ADDENDUM NO. FOUR
THORNTON WATER PROJECT
SOURCE WATER PUMP STATION
PROJECT NO. 12-777XP
CITY OF THORNTON, CO

DATE: July 16, 2026

PURPOSE: To provide additional information and clarification to the solicitation documents for the above-referenced Project.

DRILLED PIER SCHEDULE						
LABEL	DIAMETER (FT)	TOP ELEVATION (FT)	MIN PENETRATION INTO BEDROCK (FT) (NOTE 1)	DRILLED PIER BEARING ELEVATION (NOTE 2)	VERT REINF	TIES (SEE NOTE 4)
P1	2'-0"	SEE PLAN	20'-0"	5064.50	(8) #9	#4@6"
P2	3'-0"	SEE PLAN	25'-0"	----	(12) #9	#4@6"

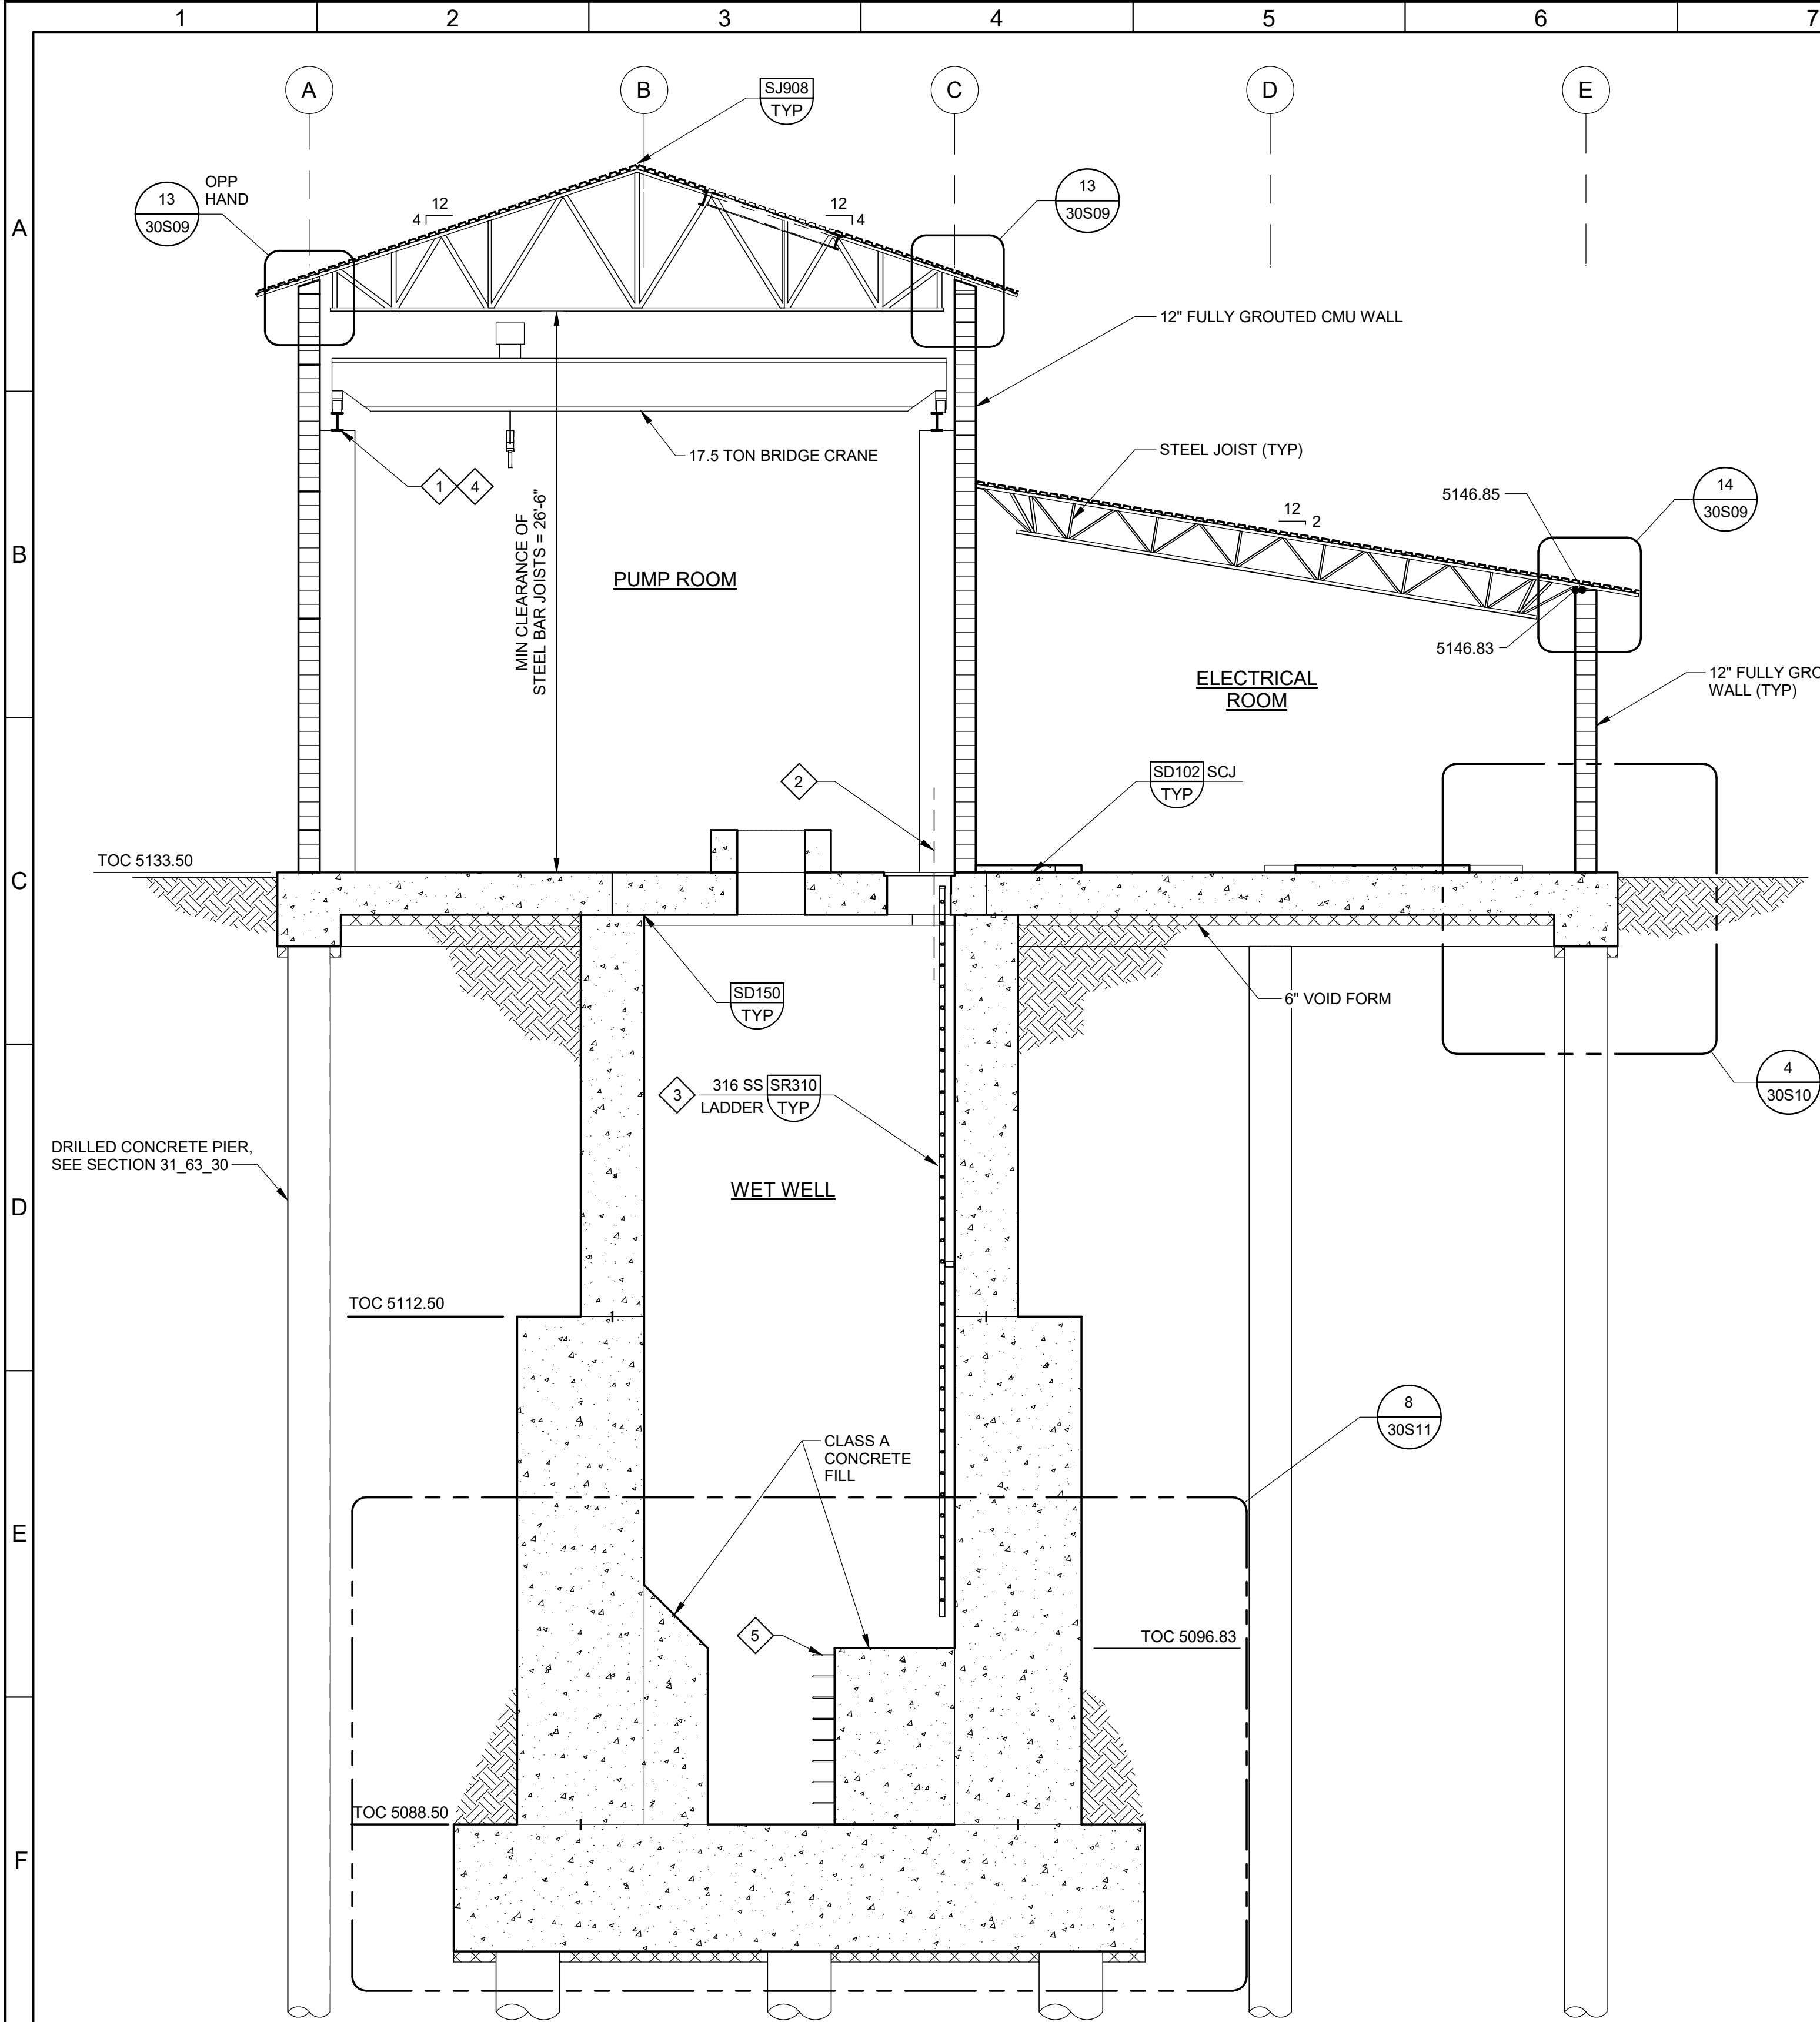
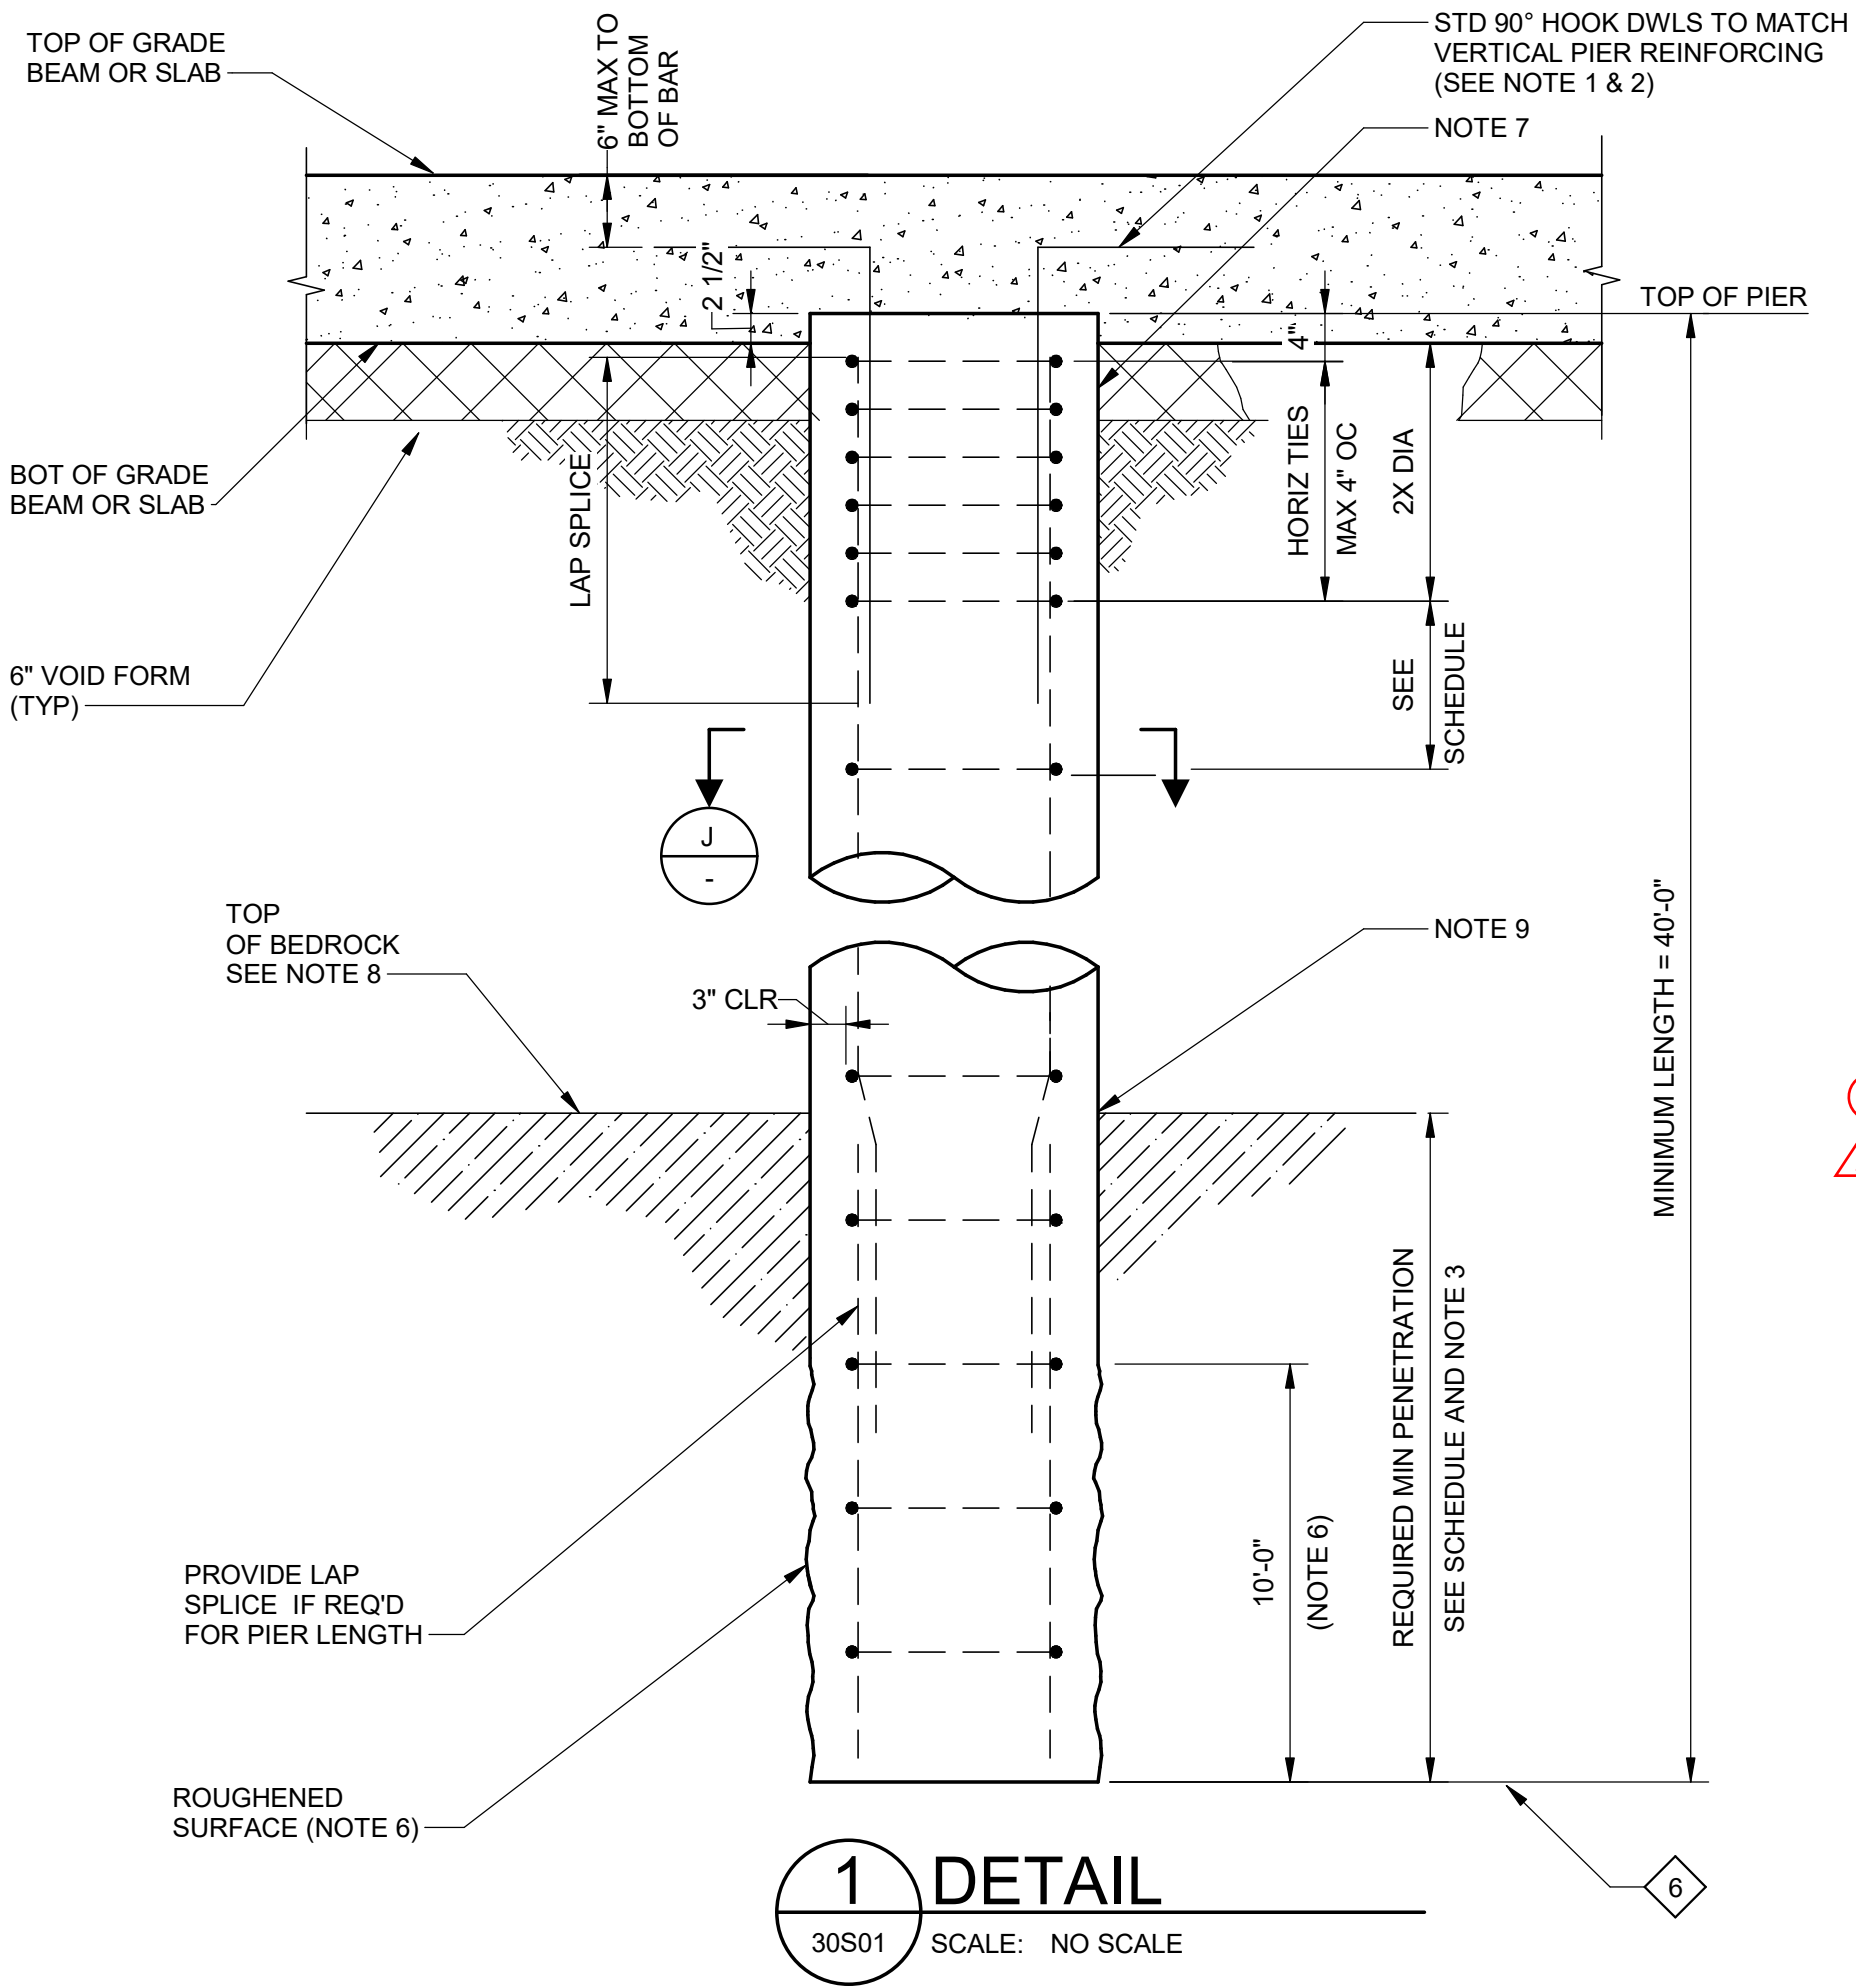
21	Per drawing 50S06 - Drilled pier schedule shows top of bedrock at elevation 5,112 and bottom of slab at elev. 5,089. Please advise.	See revised drawing included in Addendum No. 4
22	Will the Chemical Building and PRV Vault work be administered separately from the Source Water Pump Station (e.g., separate pay applications, project schedules, progress meetings, and construction management trailer), or will all work be managed together?	The Chemical Building and PRV Vault work will be administered in conjunction with the SWPS including the aforementioned items.
23	What is the estimated volume of water to be contained within the pipeline prior to the start of commissioning?	There will only be small portions of water left in the pipe. Assume the pipe is empty at the start of commissioning and Contractor will need to fill the entire pipeline
24	Where is the water discharged during the required testing of the eight high-volume blowoff valves, and are there any restrictions or special requirements for managing or disposing of the discharge?	The water is discharged into the adjacent drainages for the 8 High Volume blowoffs. Any requirements must comply with CDPHE permitting.

NOTE:
1. INCREASE BEDROCK PENETRATION AS NEEDED TO ACHIEVE THE MINIMUM TOTAL PIER LENGTH.
2. 24" DIA PIERS SHALL BEAR AT OR BELOW THE BOTTOM OF WET WELL VOID FORMATION ELEVATION. BOTH MINIMUM LENGTH AND MINIMUM BEDROCK PENETRATION CRITERIA SHALL STILL BE SATISFIED.

- INSTALL 316 SST RUNGS AT LOCATIONS BETWEEN PUMPS AS SHOWN, AT 12 INCHES OC VERTICAL SPACING. SEE ALSO DETAIL 8/30S11.
 - BOTTOM OF PIER ELEVATION SHALL SATISFY ALL OF THE FOLLOWING CRITERIA:

- MINIMUM PIER LENGTH: 40 FT.
 - MINIMUM PENETRATION INTO BEDROCK: AS SCHEDULED.
 - PIER BEARING ELEVATION: AS SCHEDULED.
- DRILLED PIER NOTES:**
- NOT USED.
